MINISTRY OF
NATIONAL DEVELOPMENT
TRANSPORTATION SAFETY BUREAU OF HUNGARY

Subject: Issue of Safety Recommendation BA2017-371-4-1A

Service Letter: 418 (page 1 of 5) Revision A

Title: Electrical System Update

Figure 1 Schematic of Primary Electrical System (Aft Mounted Battery) Before Modification

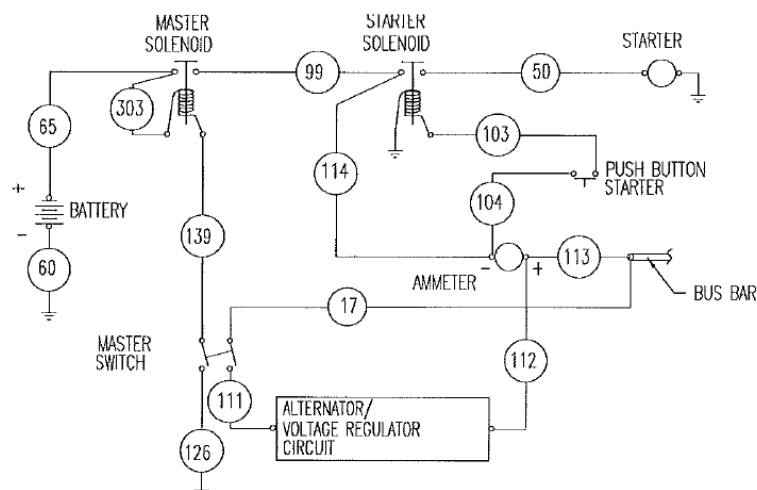
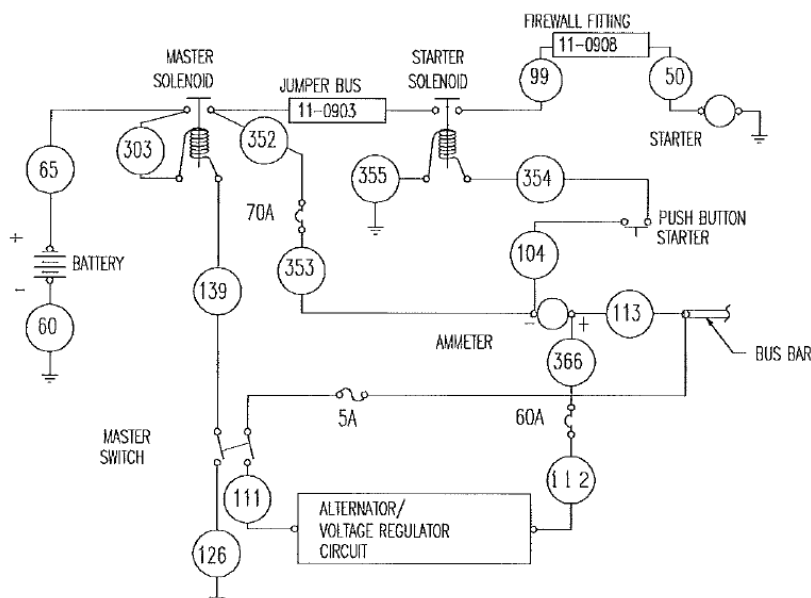
Concept: The primary electrical system on most rear mounted battery models looks similar to the schematic in figure 1. The diagram has been simplified to show only the affected areas. Upon inspection, it can be seen that there is no circuit protection for the voltage regulator circuit before the voltage regulator. This wire is in a bundle with other critical wires and is a source of concern. Also, the circuit from the battery to the bus bar is not protected. This was due to the 'sharing' of a line to the starter. To accommodate circuit protection for these two circuits, the electrical system must be modified to look similar to figure 2.

Conversion: The first item that needs to be modified is the voltage regulator circuit. Wire number 17 must
(Continued) be replaced with an inline 5-amp fuse. This is a very short wire inside the electrical panel that runs from the bus bar to the alternator half of the master switch. Note that the master switch is a single throw double pole switch and connecting to the wrong pole will ground the bus bar when the switch is thrown. This fuse can be butt spliced in place or new terminals can be installed depending on application.

Figure 3 Typical installation for a Firewall Mounted Battery

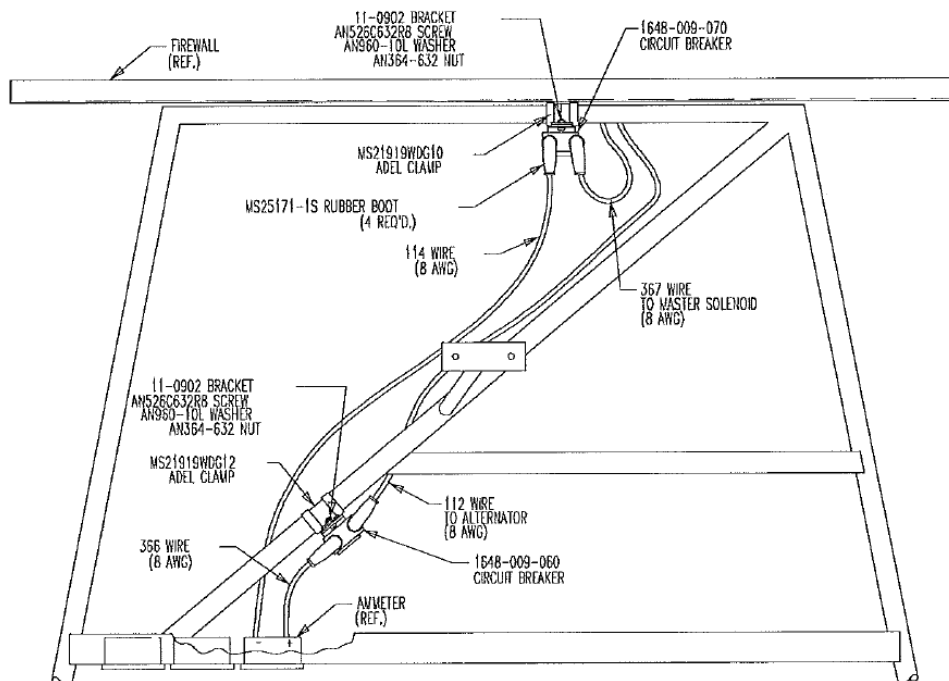
A properly installed firewall mounted battery requires the installation of circuit protection from the battery and the alternator. Mount the 70-amp battery circuit breaker inside the firewall using an Adel clamp and 11-0902 bracket. On the output side of the master solenoid, disconnect wire #114 and, mount wire #367 to the input (line) side of 70-amp circuit breaker. The wire #114 should then be attached to the output (load) side of the circuit breaker. Figure 3 depicts a typical installation.

Attach the 60-amp alternator circuit breaker to the diagonal fuselage tube with an Adel clamp and 11-0902 bracket. Disconnect the #112 wire from the ammeter and replace it with wire #366 attached to the input (line) side of the 60-amp circuit breaker. Attach alternator wire #112 to the output (load) side of the 60-amp circuit breaker. Figure 3 depicts a typical installation.

Figure 4 Assembly of Firewall Fitting

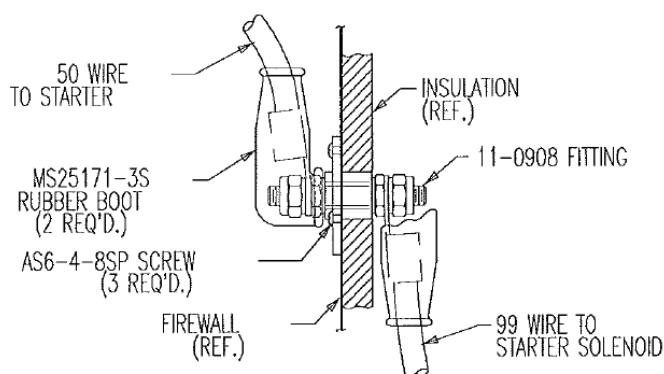
Remove the firewall fitting for wire #99 and push inside the airplane. Install fitting 11-0908 in the firewall in place of the former fitting. Mount wire #50 to the engine side of the fitting and wire #99 to the insulation side of the fitting. Use a rubber boot over each connection. The Assembly is depicted in figure 4. The starter solenoid should then be mounted to the battery board in close proximity to the master solenoid as depicted in Figure 5. This may require that the master solenoid be shifted as well. The wire #99 should be removed from the master solenoid and mounted to the starter solenoid. The 11-0903 jumper bus should then connect the two solenoids. The starter solenoid needs to be grounded if it is mounted on a wood battery board. Use wire #355 to connect to an appropriate ground. Route wire #354 up to the starter button in place of the former wire #103. Figure 5 depicts a typical installation.

Figure 5 Typical Battery Board Installation

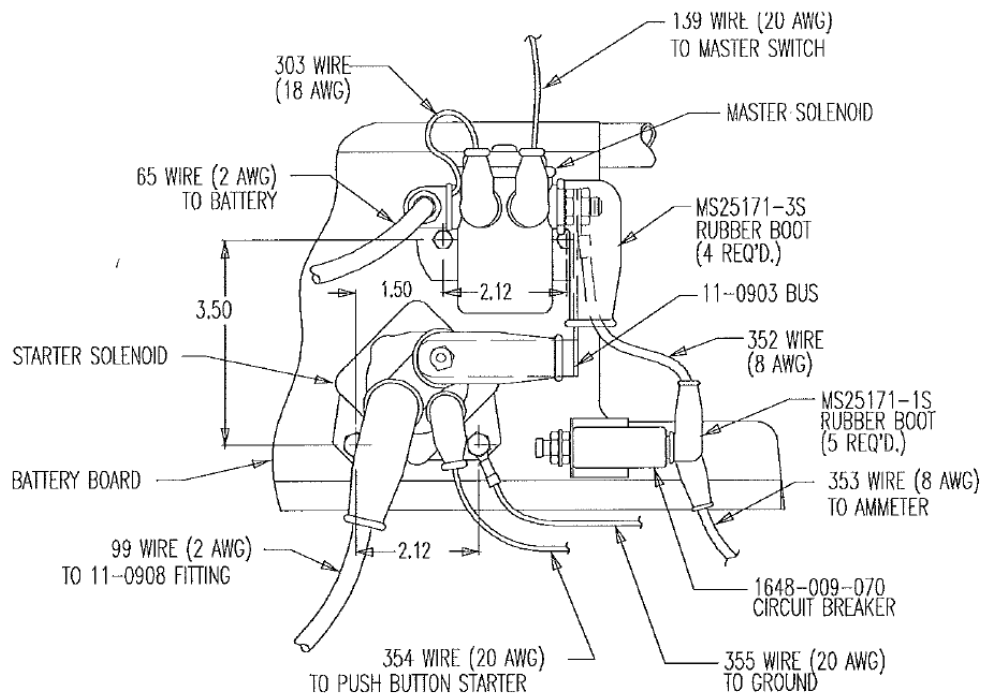
Power to the bus bar from the battery must be restored by replacing wire #114. On the output side of the master solenoid, mount the short wire #352 to a 70-amp circuit breaker. Mount the breaker to the battery board using an appropriate bracket. This is also depicted in figure 5. Route the longer wire #353 to the ammeter in place of wire #114. The #353 and #354 wires should be bundled with wire # 99 to keep them away from fuel lines and control systems.

Figure 6 Under Dash Installation for Aft Mounted Battery

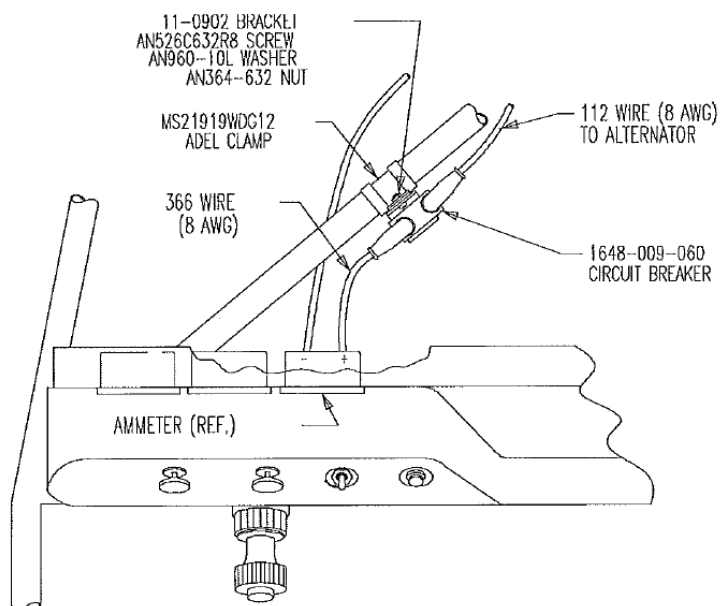
Disconnect wire #112 from the ammeter and replace it with wire #366 attached to the input (line) side of the 60-amp circuit breaker. Attach alternator wire #112 to the output (load) side of the 60-amp circuit breaker. Figures 5 and 6 depict a typical installation.
